Design Review & Historic Preservation Board Meeting Agenda

Design review application - Downtown Design Guidelines (DDGs) - 2nd Street Apartments - REVISION

RE: PUYALLUP SECOND STREET APARTMENTS

Staff Review Table - PLDDG20240024

2nd Street Apartments - Puyallup	
Exterior Elevations	
04-08-24	Page 4 of 6

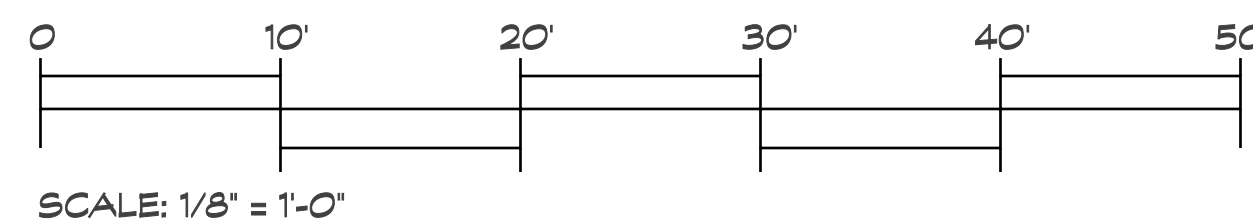
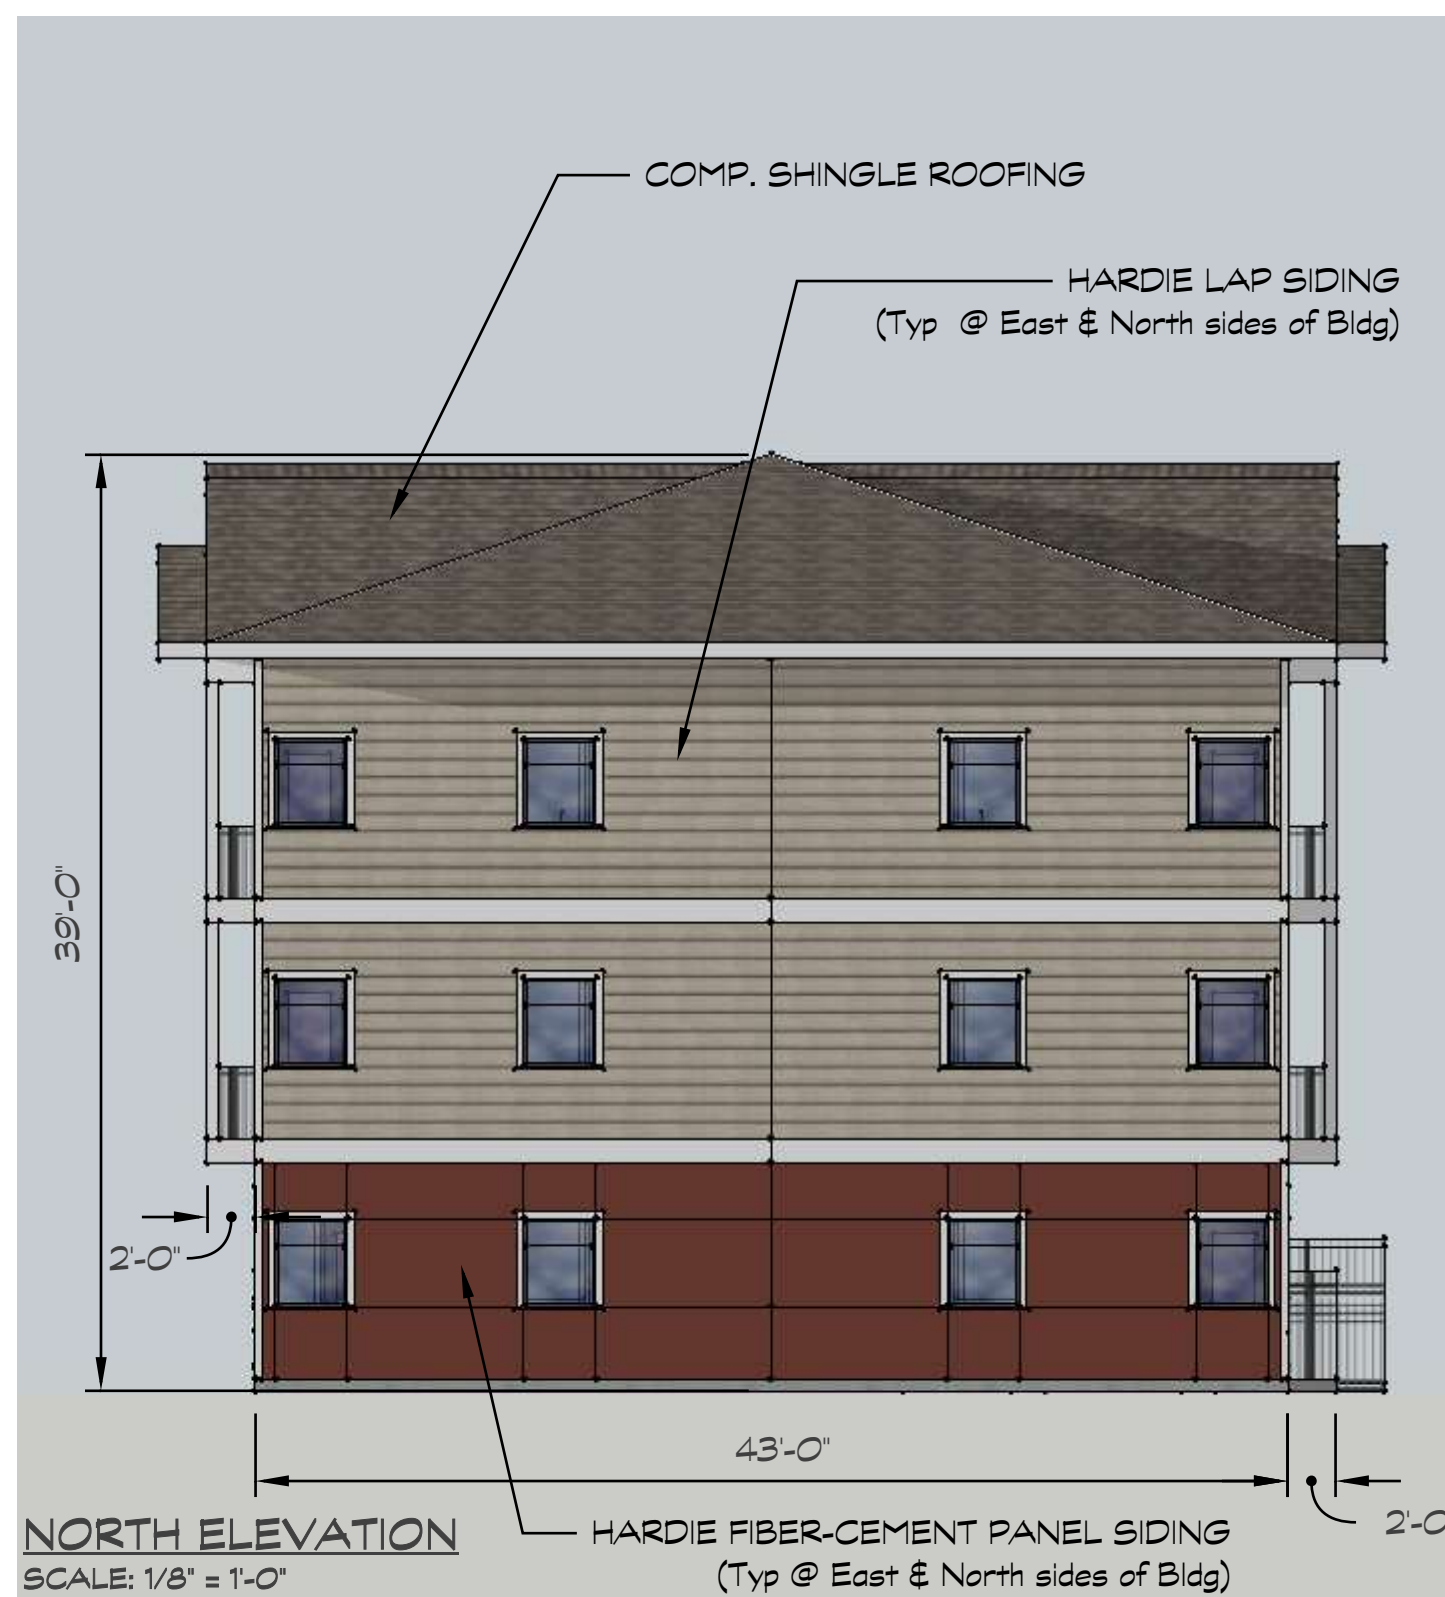
We revised page 4 with the exterior elevations to show the percentages of materials proposed. The reason the areas do not total 100% is that we have the windows as part of the total.

Note that all of the materials we are proposing on the two street elevations are considered "high quality" as defined by the Design Manual. For the stucco, we are proposing traditional stucco with control joints. We are not proposing EIFS anywhere on this project. We total over 30% material for the lap siding.

We could combine the stucco and board and batten siding to get to about 30% but I am wondering if that is necessary when we are providing 100% high quality materials.
